ADDENDUM TO IFB

Redwood Coast Energy Authority CALeVIP Charging Network Updates

**Addendum #1
September 4, 2020**

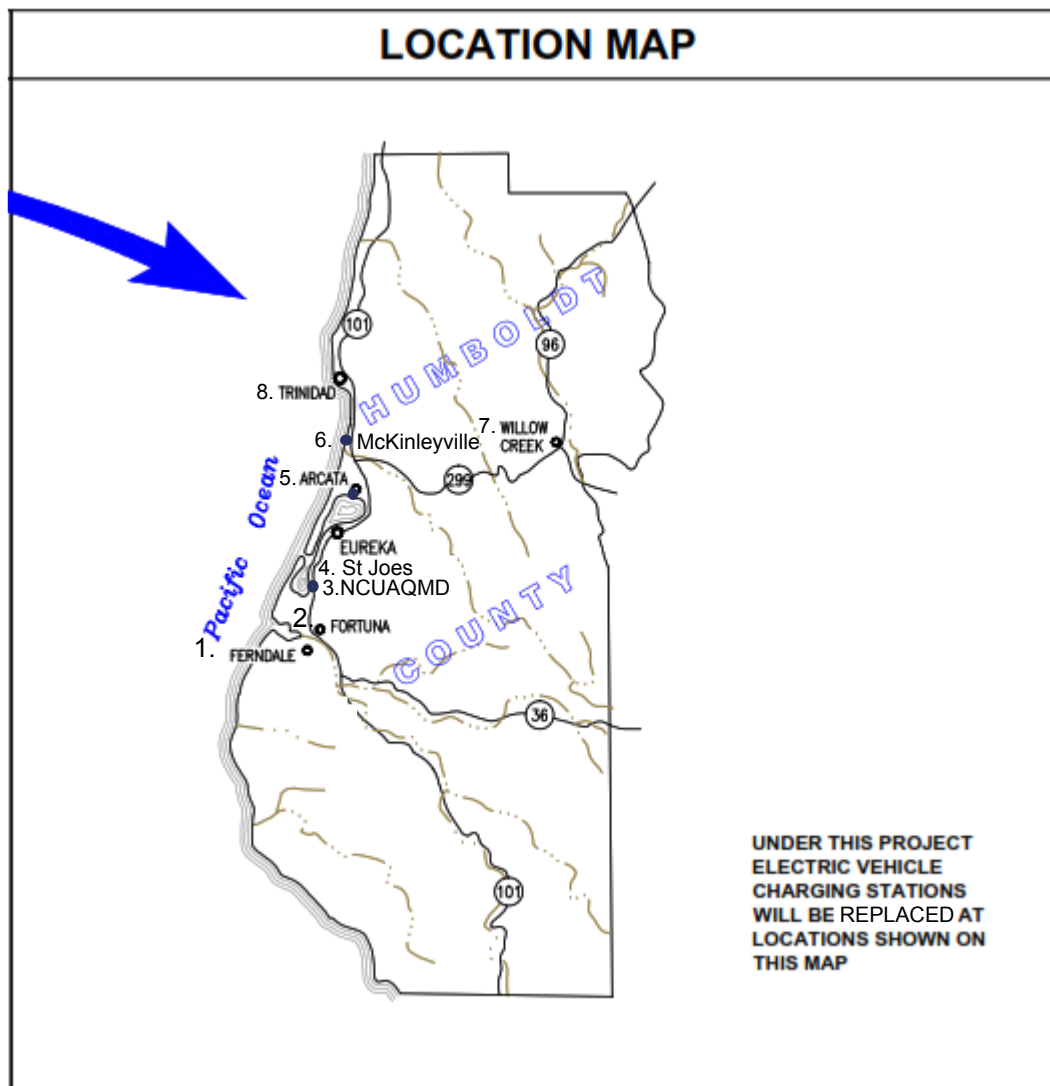
Question: Sketch SK-07 discusses two types of signs, however the subsequent sketches are not clear where these signs are required. Please specify where each type of sign will be required for each of the four job sites and also if any of the existing signs will need to be relocated.

Answer: The notations about signage on sketch SK-7 were incorrect. No van accessible signs should be installed at the site. No new signage will be installed as part of this project, and no signage will be relocated.
